U.S. NUCLEAR REGULATORY COMMISSION OFFICE OF INSPECTION AND ENFORCEMENT

Reports No. 50-295/80-05; 50-304/80-04

Facility Name: Zion Units 1 and 2

Health Physics Appraisal on March 10-21, 1980 (Reports No. 50-254/80-05 and 50-265/80-04)

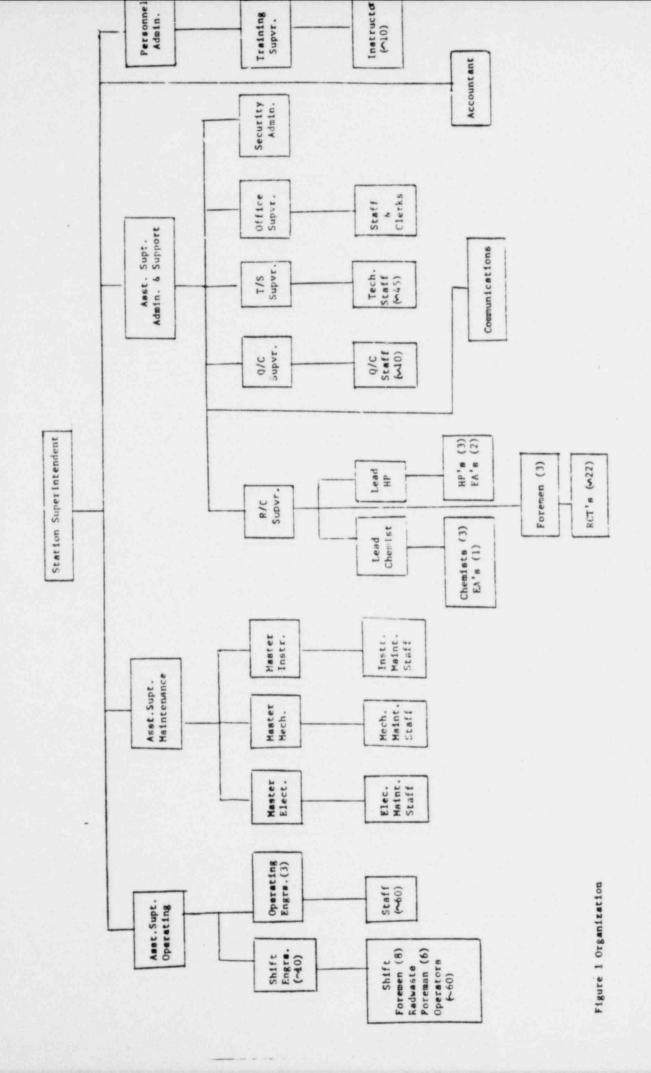
Total staffing of the Radiation/Chemistry Department (Figure 1) is approximately 38, including a part-time clerk. Total plant staff is approximately 400. The RCT complement has been augmented by as many as 30 technicians from NUMANCO, Inc. during outages. Following the most recent outage, about 13 contract technicians were retained to cover anchor bolt inspection. The personnel resources available to the department are, therefore, considerable. However, at certaj times and in certain areas, understaffing and other weaknesses exis RCT staffing appears adequate for normal operating periods. It may be inadequate during outages when some individuals work several weeks of uninterrupted 10 to 12-hour days. However, part of the problem appears to be inefficient use of the RCT group. More use of specialists, splitting of chemistry and health physics functions, better RCT qualification criteria, and better in-plant supervision would both upgrade the program and increase efficiency. The RCT group in general represents a significant resource of talent and experience that is underutilized and underappreciated. Considerable improvement in efficiency would be realized by the use of permanently assigned and appropriately trained clerks for maintaining files and records and performing other clerical functions now done by RCT's, foremen, and other personnel.
